## AGENDA ITEM SUMMARY REPORT

**APPLICATION NO.:** Design Review 1-20 (DR 1-20)  
Minor Use Permit 4-20 (MUP 4-20)

**REQUEST:** Design Review Permit and Minor Use Permit to 1) reconstruct a mortuary that was destroyed by fire at 445 East Fir Street; 2) expand a non-conforming land use (mortuary); and 3) request a reduction in off-street parking requirements.

**LOCATION:** 445 East Fir Street

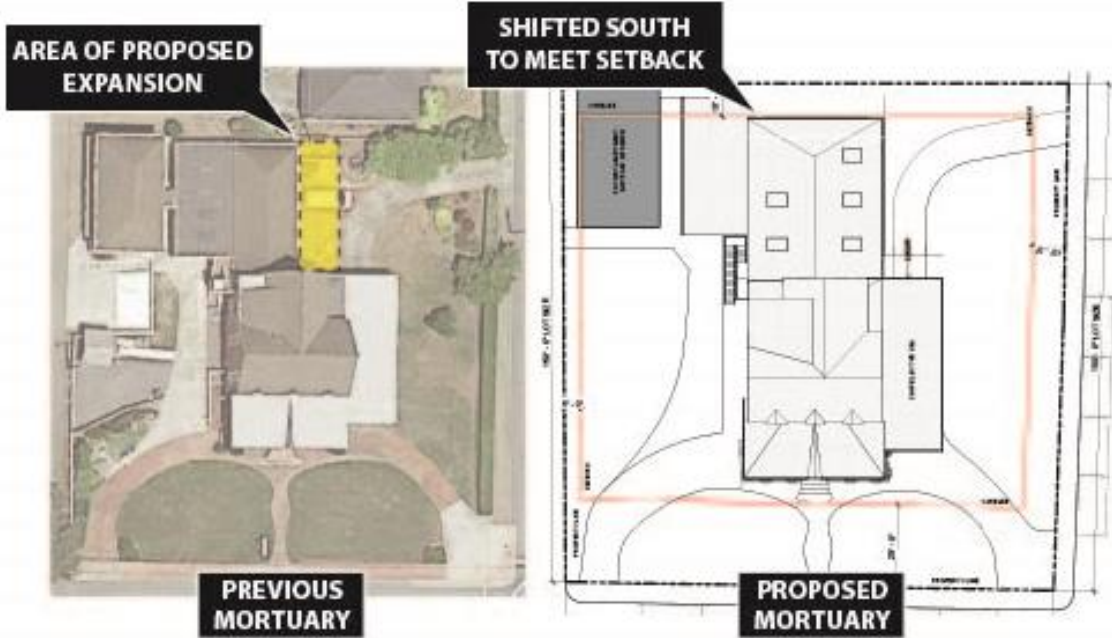
The images below depict the proposed building footprint beside an aerial image of the property prior to the fire, and a comparison of the proposed elevations and the former elevations. See **Attachment 1** for complete project plans with views of all elevations. Aside from an approximately 800 SF expansion on the northeast side of the building, the proposed massing and scale would be equal to the former building, which was an established part of the community. The design would similarly mimic the previously-established structure.

As stated above, the proposed replacement structure would be largely consistent with the previously-existing mortuary. However, the replacement structure would be shifted to the south in order to meet the Low-Density Residential zoning district’s setback requirements, making the structure in conformance with the requirements of surrounding development.
